9.3 Process Auxiliaries

The information in this section of the reference ABWR DCD, including all subsections, tables, and figures, is incorporated by reference with the following departures and supplements.

Figure 9.3-10 Breathing Air System Flow Diagram

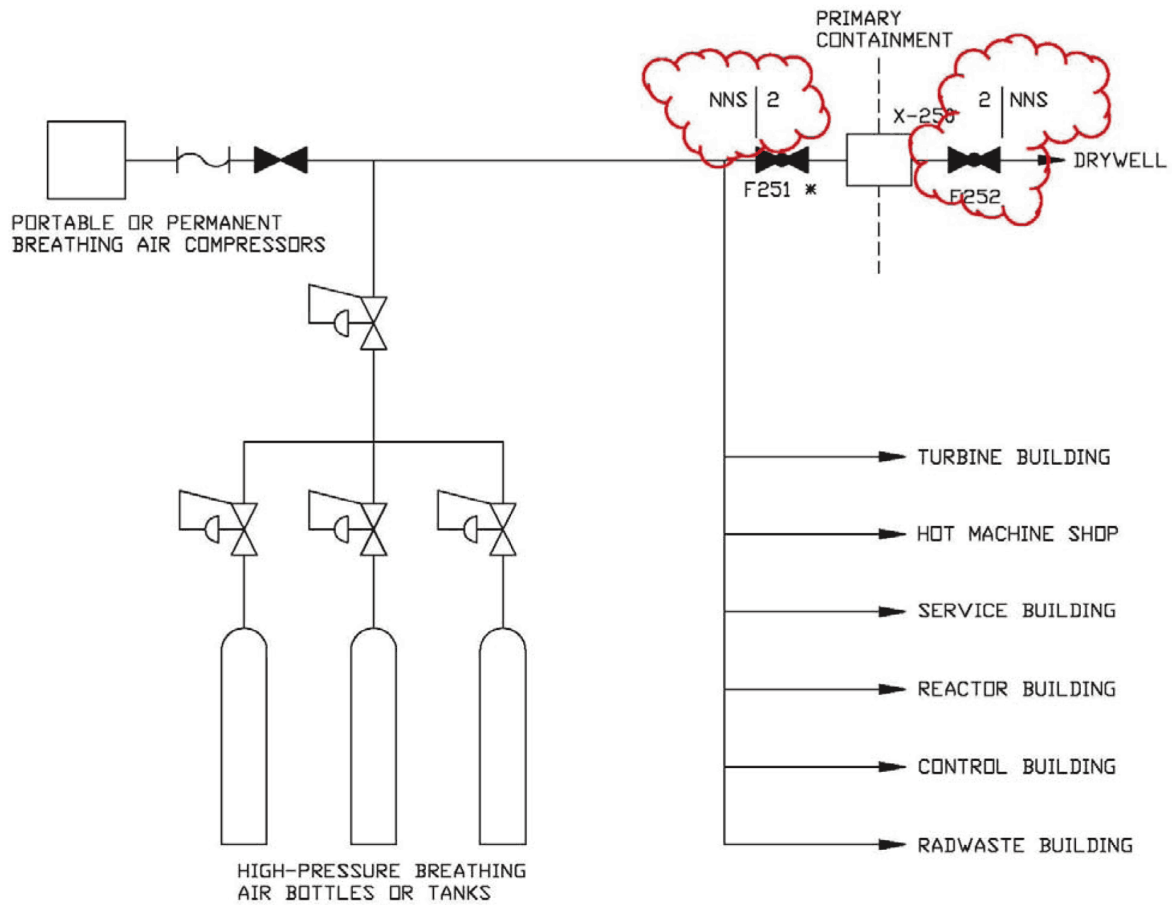
The BAS is sized to provide 100% of the peak air consumption using the bottled breathing air supply and a portable permanent breathing air compressor supply system, as needed. The compressor(s) will be of the oil-less, breathing air type.

The BAS flow diagram is shown in Figure 9.3-10.

<u>Pressure (design of BAS)</u>	<u>689 kPaG</u>
<u>Pressure (design of self-contained breathing apparatus charging)</u>	<u>17.23 MPaG</u>
<u>ANSI Compressed Gas Association (CGA) 7.1-1997, "Commodity Specification for Air"</u>	<u>Air Quality Grade D</u>
